II. Responses to Comments

A. Introduction

Sections 21091(d) and 21092.5 of the Public Resources Code and CEQA Guidelines Section 15088 govern the lead agency's responses to comments on a Draft EIR. CEQA Guidelines Section 15088(a) states that "[T]he lead agency shall evaluate comments on environmental issues received from persons who reviewed the draft EIR and shall prepare a written response. The lead agency shall respond to comments that were received during the notice comment period and any extensions and may respond to late comments." In accordance with these requirements, this section of the Final EIR provides the responses prepared by the City of Los Angeles Department of City Planning (City) to each of the written comments received regarding the Draft EIR.

Figure II-1
 Reduced Alternative 5 Conceptual Plot Plan

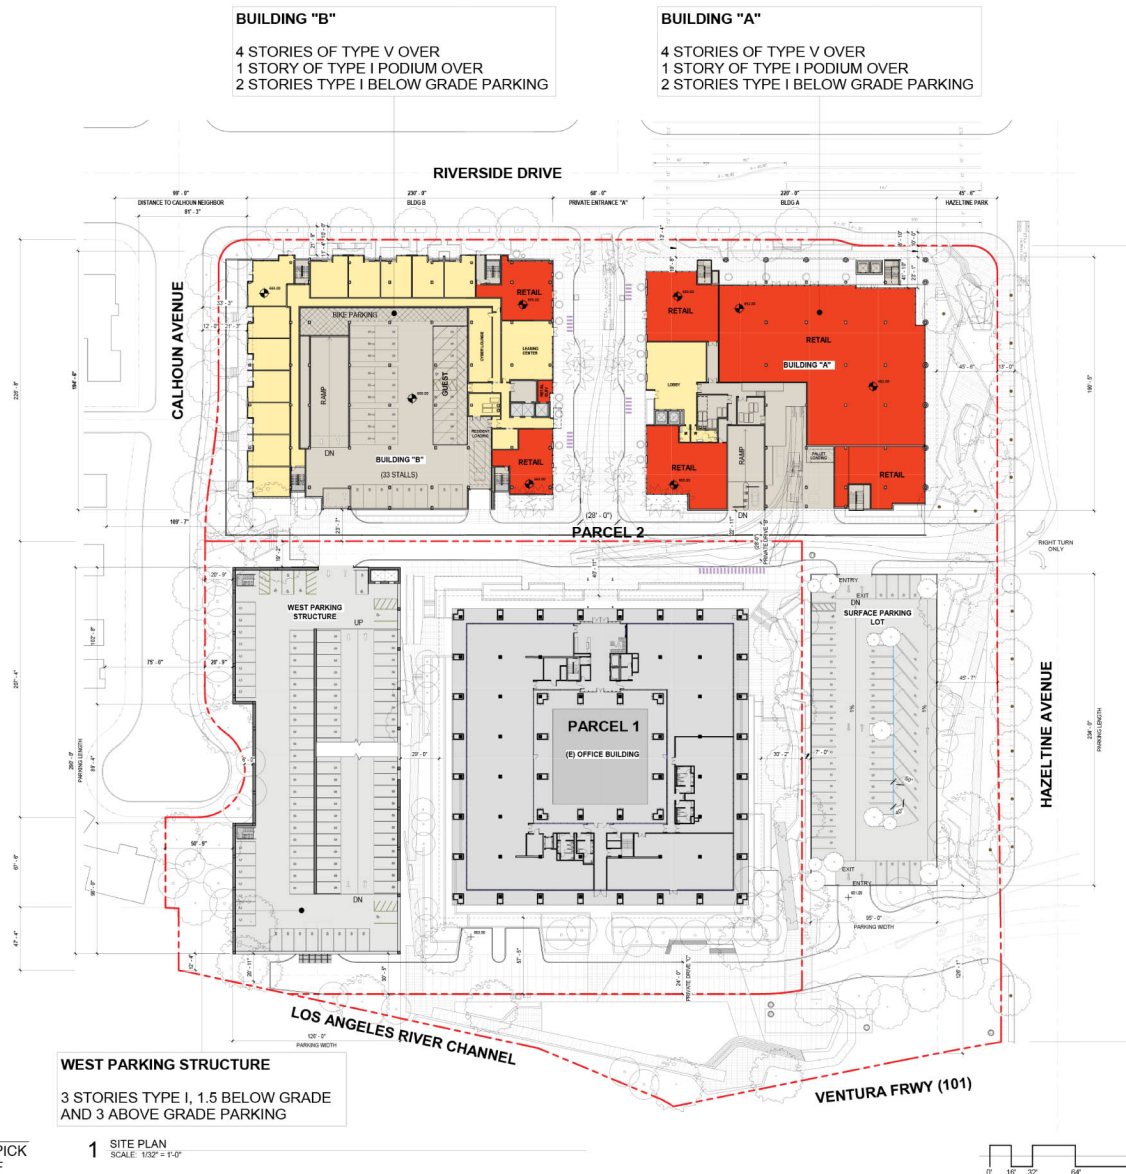
As illustrated in Figure II-1 on page II-20, to further address comments on the Draft EIR regarding the massing of the Project, the proposed residential uses would be provided in only two buildings (Building A and Building B). Building C proposed along Calhoun Avenue would be removed as part of Reduced Alternative 5. Building A would remain on the northeastern portion of the Project Site, at Riverside Drive and Hazeltine Avenue, and Building B would remain within the northwestern portion of the Project Site, adjacent to Building A, near Riverside Drive and Calhoun Avenue. The heights of the buildings under the Reduced Alternative 5 would be similar to the Project and Alternative 5. Specifically, Building A would remain at 74.5 feet and Building B would remain at 60.5 feet.

Reduced Alternative 5 would require 798 parking spaces. Reduced Alternative 5 would exceed the parking requirements of the LAMC and would provide 1,141 parking spaces to adequately serve the proposed uses. As shown in Figure II-1, parking has been redesigned compared to Alternative 5 and would be provided in three separate parking facilities instead of two parking facilities. Specifically, the six-level parking structure (four above-grade levels and two subterranean levels) proposed along Hazeltine Avenue has been relocated to the western portion of the Project Site, west of the Sunkist Building, along Calhoun Avenue, and reduced to five levels (three above-grade levels and two subterranean level) with rooftop parking. However, due to the sunken grade along the western portion of the Project Site, only two parking levels would be visible from the Calhoun Avenue residences located across the street from the Project Site. In addition, a surface parking lot is now proposed east of the Sunkist Building to serve mainly the neighborhood serving commercial uses proposed within Buildings A and B. The parking structure located west of the Sunkist Building would provide 477 parking spaces and would primarily serve the Sunkist Building (in addition to 39 stalls located below the Sunkist Building). The remaining spaces would be provided within the proposed surface parking lot and in two subterranean parking levels provided below Building A and Building B.

Areas for passenger drop-off and pick-up, including personal vehicles, ridesharing vehicles, Taxi, Uber and Lyft type services would be provided on-site. As illustrated in Figure II-1 on page II-20, above, these spaces would be provided by installing turn-out areas along the south side of the interior roadway between the Sunkist Building and new commercial/residential buildings and on both sides of the drive from Riverside Drive between the new residential/commercial buildings.

Figure II-6
Reduced Alternative 5 - West Parking Elevation

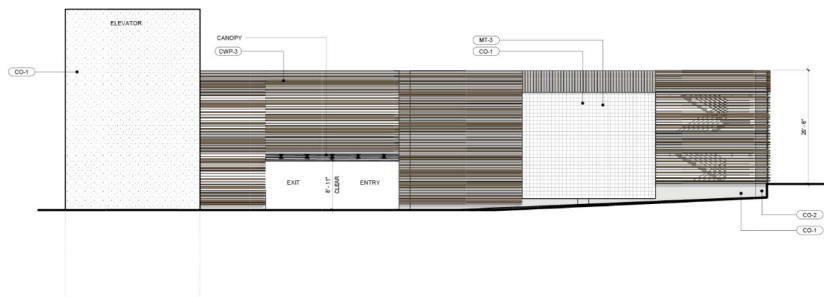
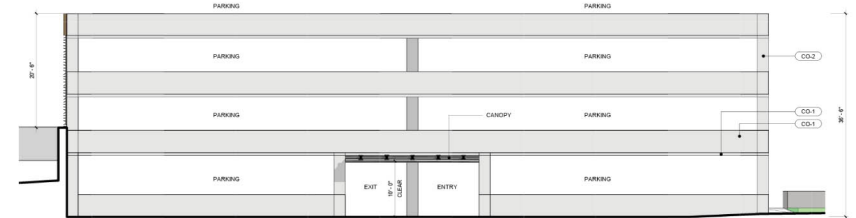
As measured from grade at Calhoun Avenue, the parking structure would be 37.5 in height and would be lower than the parking structure proposed by the Project and Alternative 5 along Hazeltine Avenue (50 feet 9 inches) as well as Building C (59 feet). A majority of the parking structure would be set back at least 19 feet 3 inches from the property line to provide a buffer from the residences along Calhoun Avenue. In addition, a green screen comprised of a wire mesh panel system with vines and new landscaping would be provided to visually shield the parking structure from the residences along Calhoun Avenue. Along Hazeltine Avenue, the newly proposed surface parking lot would open up the Project Site and expand visibility of the Sunkist Building.

Figure II-7
Reduced Alternative 5 - Hazeltine Parkway Elevation

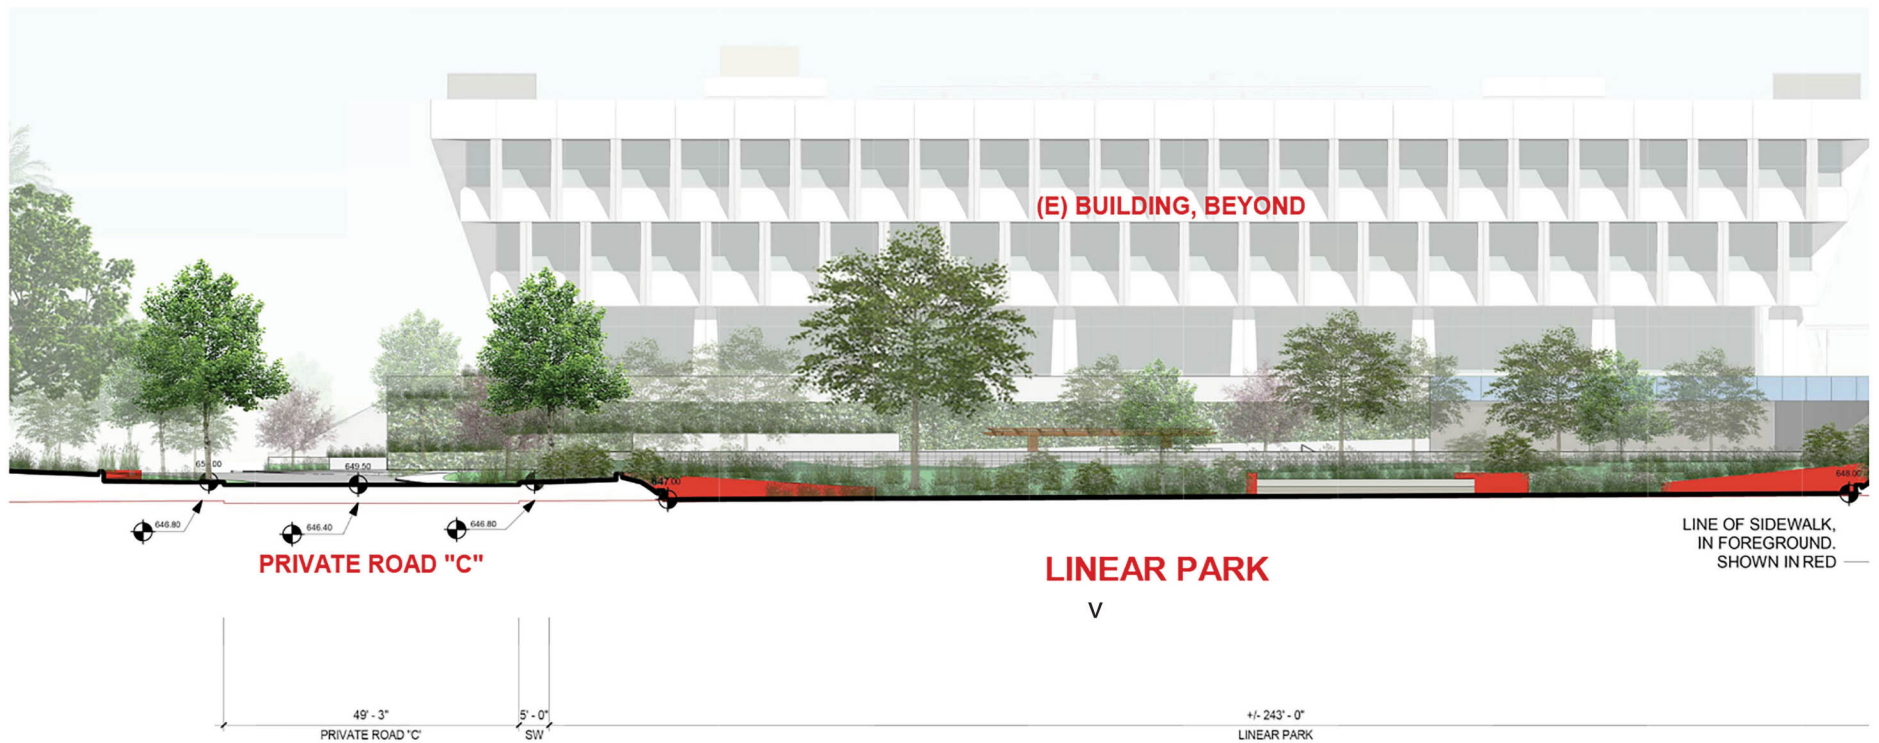
While vehicular access would continue to be via Riverside Drive and Hazeltine Avenue, Reduced Alternative 5 incorporates design modifications that enhance access and circulation to and throughout the Project Site and from Hazeltine Avenue. Specifically, the proposed surface parking lot along Hazeltine Avenue would include a pass-through lane for all vehicles that would allow access to Building A from the Project Site's southerly Hazeltine Avenue driveway, as opposed to traveling northbound and turning left at Hazeltine Avenue and Riverside Drive. Additionally, Hazeltine Avenue is proposed to be restriped to provide a dual southbound left-turn entry into Westfield's signalized driveway. This would reduce the potential for queuing into the Westfield parking garage along Hazeltine Avenue. Based on community input, the Project Site's northerly Hazeltine Avenue driveway would be restricted to only right-turn in and right-turn out access to improve circulation along Hazeltine Avenue. Project residents and patrons traveling northbound on Hazeltine Avenue would be prohibited from turning left into the northerly Hazeltine Avenue driveway.
